Metropolitan Historic Zoning Commission
Sunnyside in Sevier Park
3000 Granny White Pike
Nashville, Tennessee 37204
Telephone: (615) 862-7970

STAFF RECOMMENDATION
2803 Blair Boulevard
December 16, 2020

Application: New Construction—Addition
District: Hillsboro-West End Neighborhood Conservation Zoning Overlay
Council District: 18
Base Zoning: RS7.5
Map and Parcel Number: 10410024000
Applicant: Preston Quirk
Project Lead: Melissa Baldock, melissa.baldock@nashville.gov

<p>Description of Project: Application is to construct a rear addition and ridge raise and to enclose a side porch.</p> <p>Recommendation Summary: Staff recommends approval of the addition with the following conditions:</p> <ol style="list-style-type: none">1. There be no front yard paved parking;2. Staff approve a masonry sample, all windows and doors, and the roof shingle color prior to purchase and installation; and,3. The HVAC be located behind the house or on either side, beyond the mid-point of the house. <p>With these conditions, staff finds that the proposed addition meet Section II.B. of the design guidelines.</p>	<p>Attachments A: Site Plan B: Elevations</p>
--	--

Figure 2. The arrow points to the front parking area.

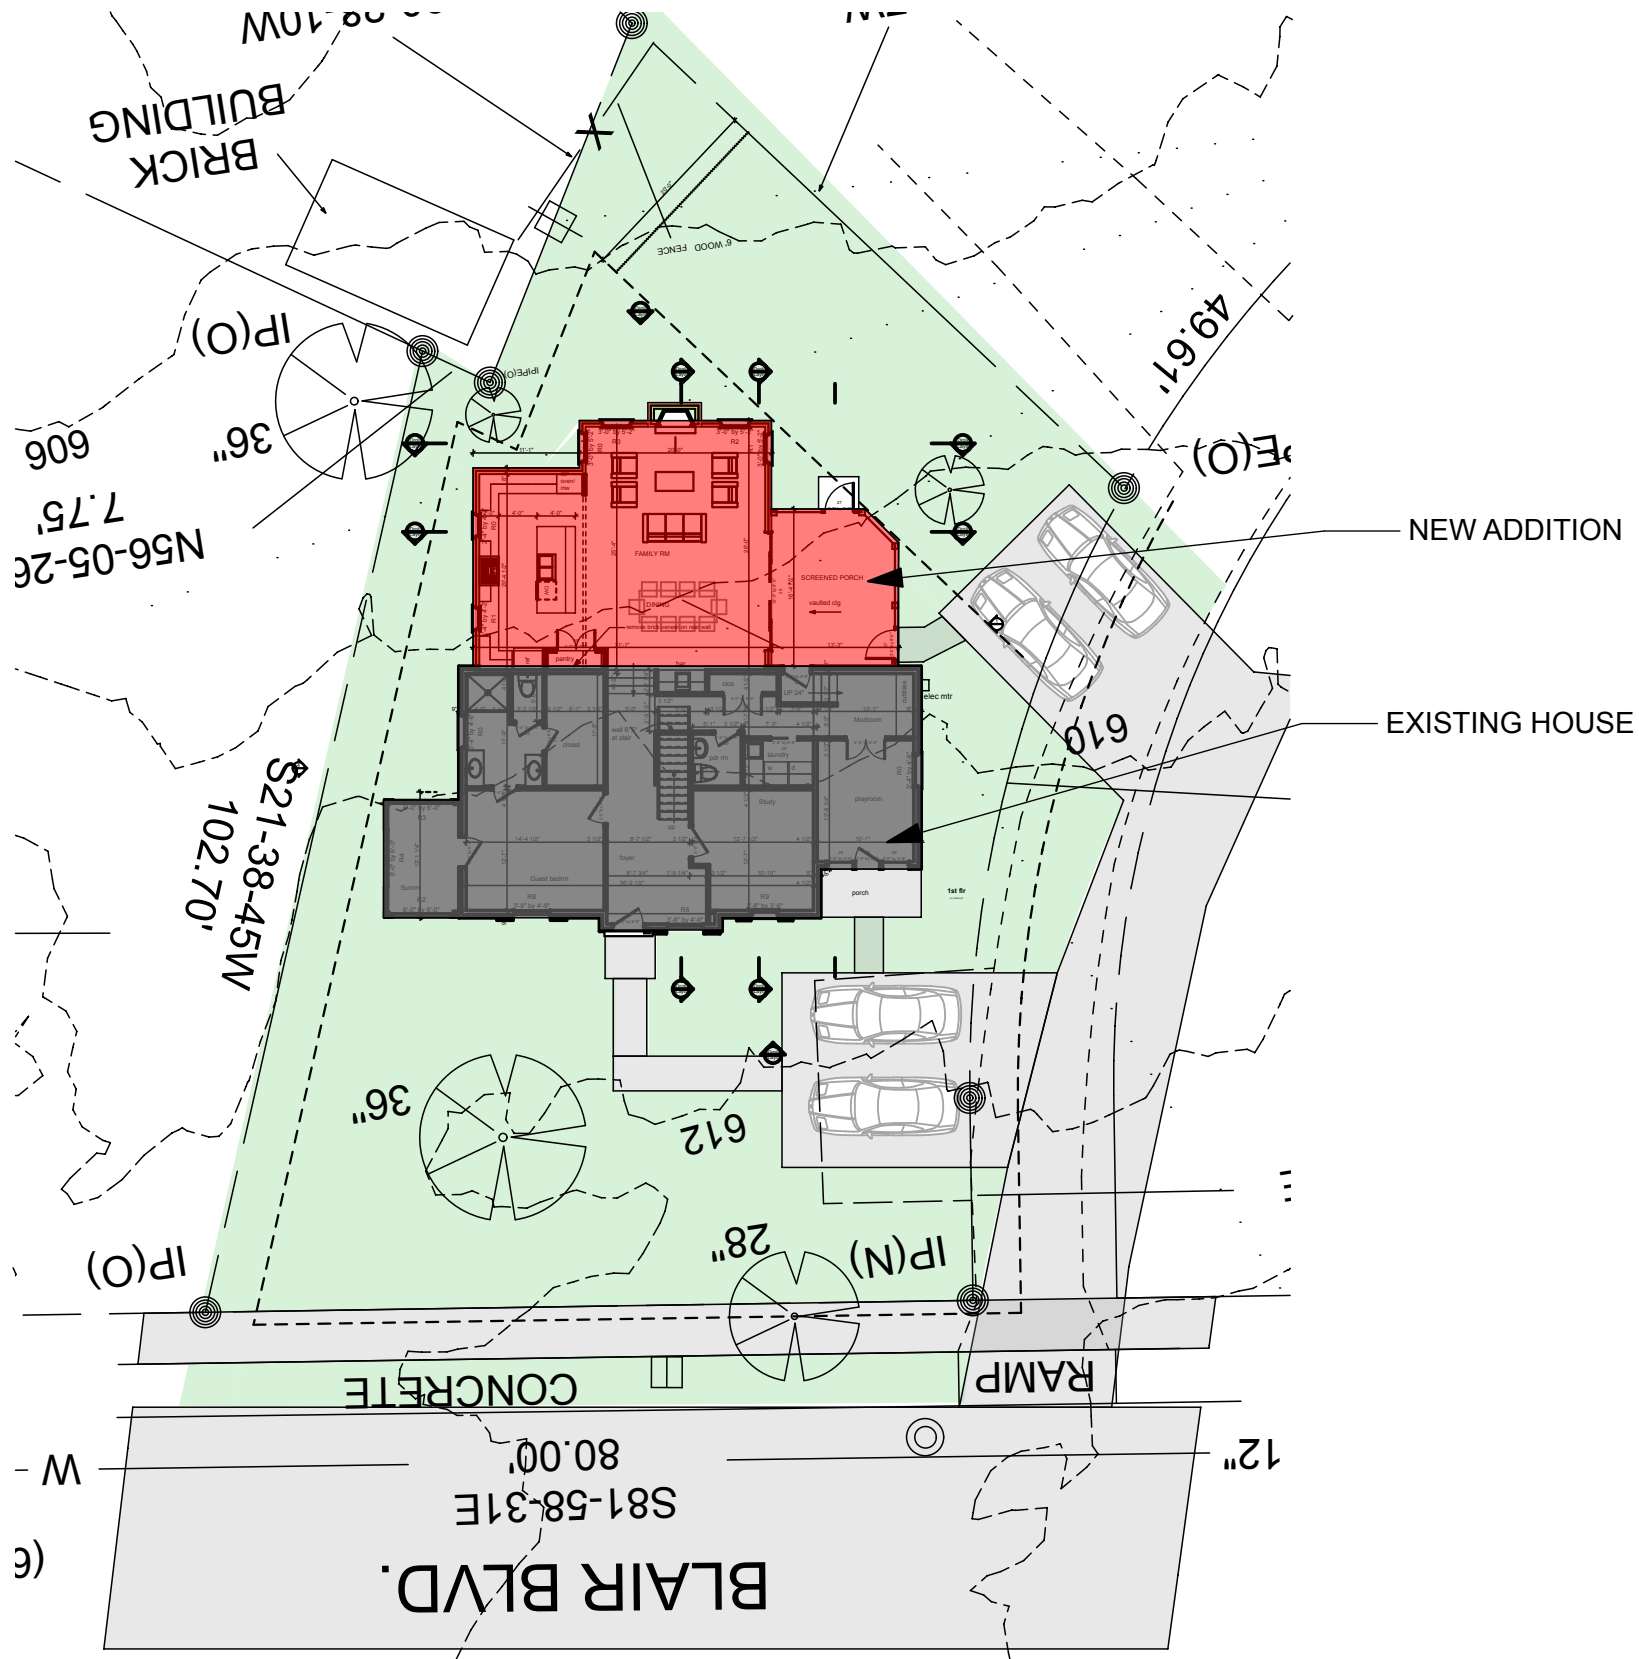
Orientation: The addition will not alter the house’s orientation towards Blair Boulevard. Vehicular entry will be via the side alley. The site plan shows front yard parking, which does not meet the historic context. In the past, there has been a gravel driveway in the front yard, which is currently beginning to have grass grow over it (Figure 2). Staff recommends that this area not be paved to be formal parking as front-yard parking is not a historic development pattern and there is space to park behind the house.

With the condition that there be no front yard paved parking, staff finds that the project meets Sections II.B.1.f. and II.B.2. of the design guidelines.

1 ROOF PLAN
SCALE: 1/8" = 1'-0"

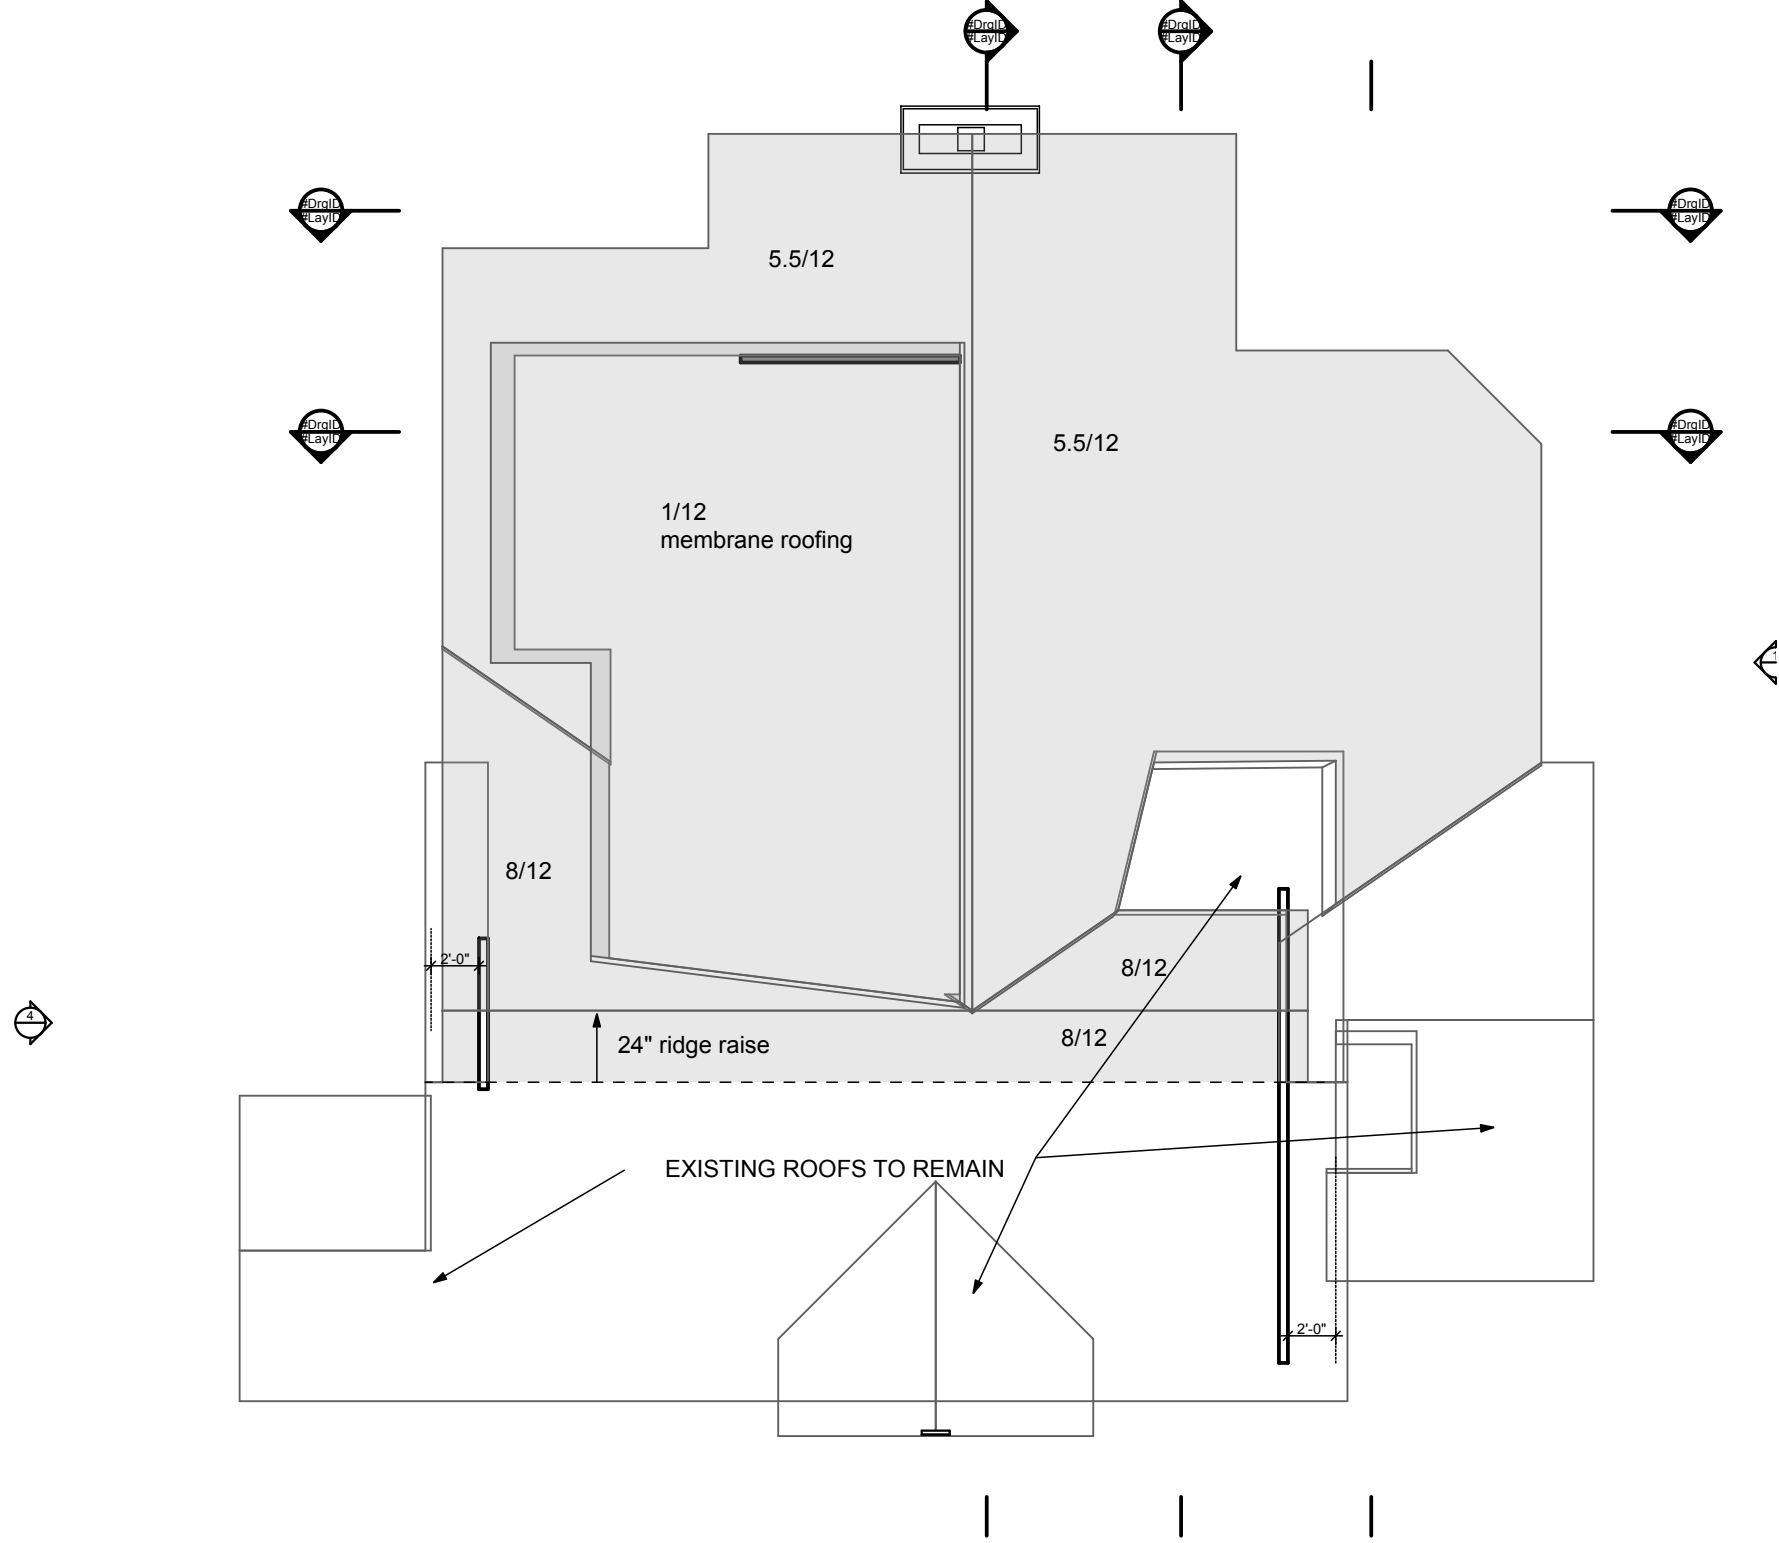
Roof form: The proposed addition includes a two-foot (2’) ridge raise which is inset two feet on each side. The main roof form has a 8/12 and 5/12 gables and a low slope shed roof. Staff finds that these roof forms are compatible with the historic house and the historic context.

Staff finds that the proposed roof forms to meet Sections II.B.1.e. and II.B.2. of the design guidelines.
